**FEDERAL COMMUNICATIONS COMMISSION**

**AUDIO DIVISION**

In re: K247BU, Lancaster, CA  
BMPFT-20150302ABK  
Facility ID # 142301

THE FOLLOWING IS A LIST OF THE DATA WHICH APPEARS ON THE ABOVE MAP

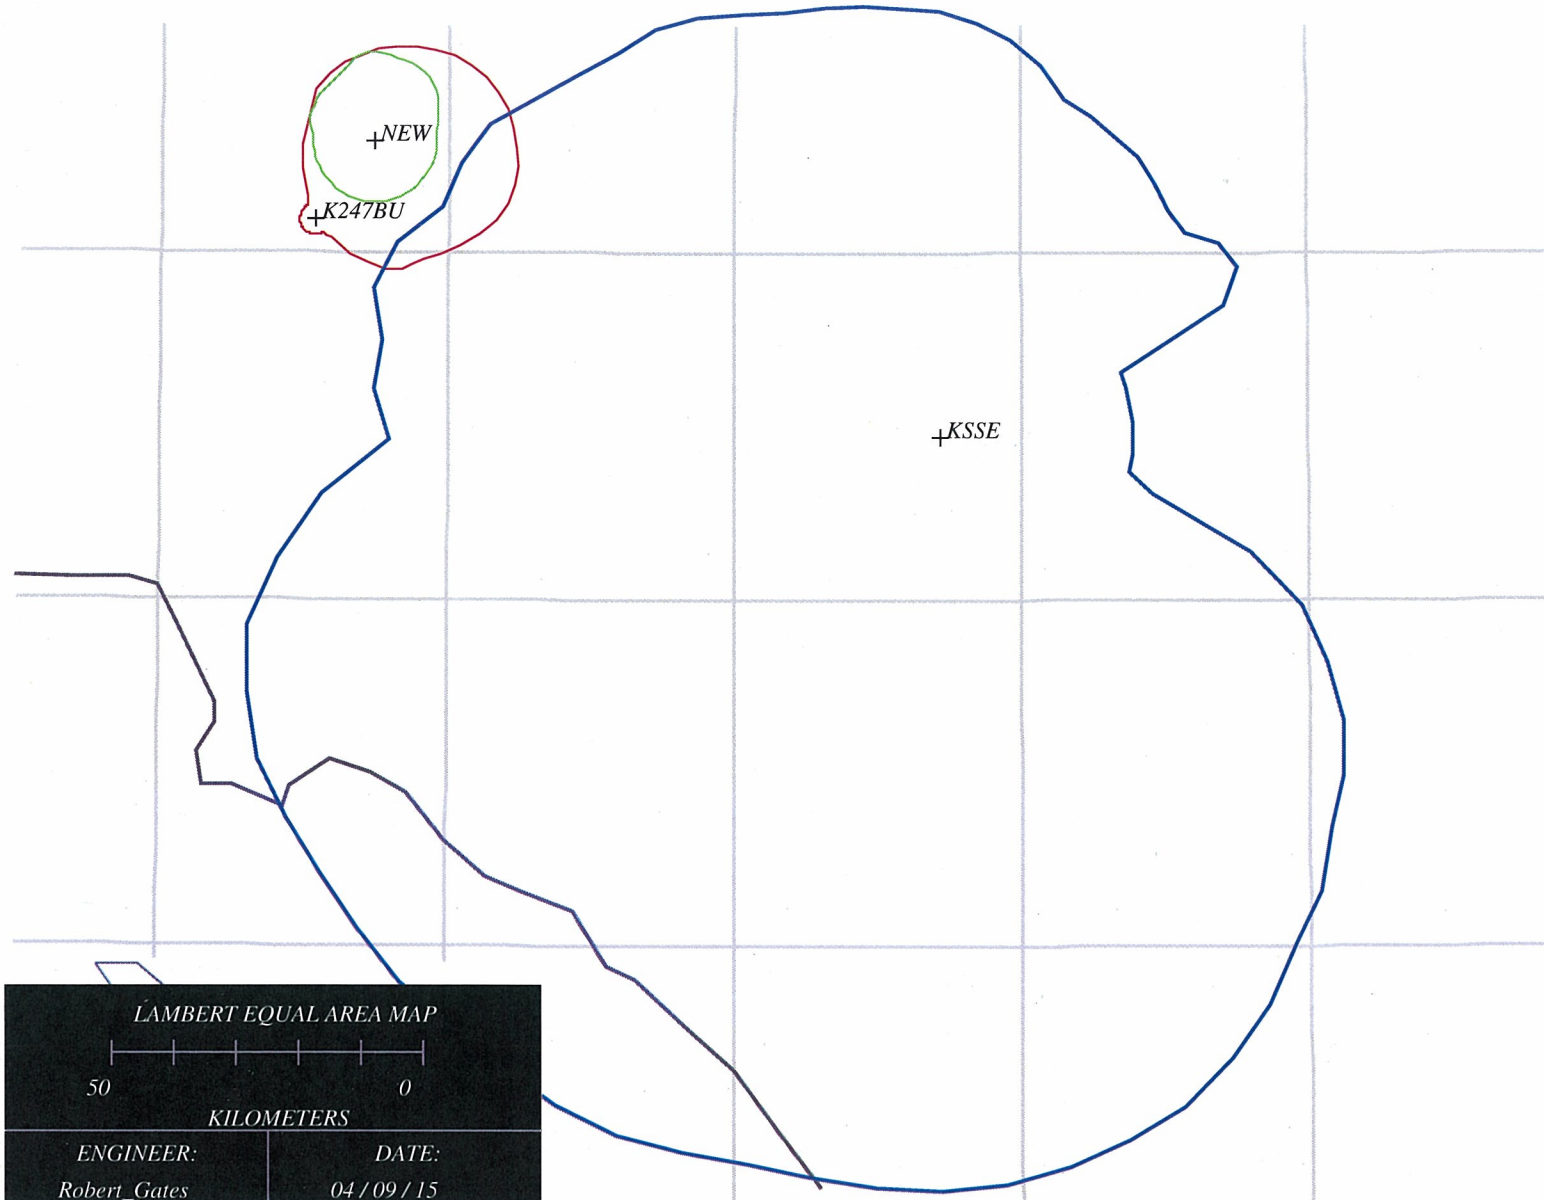
An engineering study has revealed the application violates 47 C.F.R. § 74.1204(a)(1) with respect to KLYY(FM), Riverside, California (BLH-19951215KD). Section 74.1204(a) states that an application for a FM translator station will not be accepted if the proposed operation would involve prohibited overlap of predicted field strength contours with any other authorized station. The proposed 48 dBu interference contour overlaps with the 54 dBu protected contour of KLYY(FM). This violation was not addressed.

In light of the above, the application BMPFT-20150302ABK is unacceptable for filing pursuant to 47 C.F.R. § 73.3566(a) and IS HEREBY DISMISSED. This action is taken pursuant to 47 C.F.R. § 0.283.
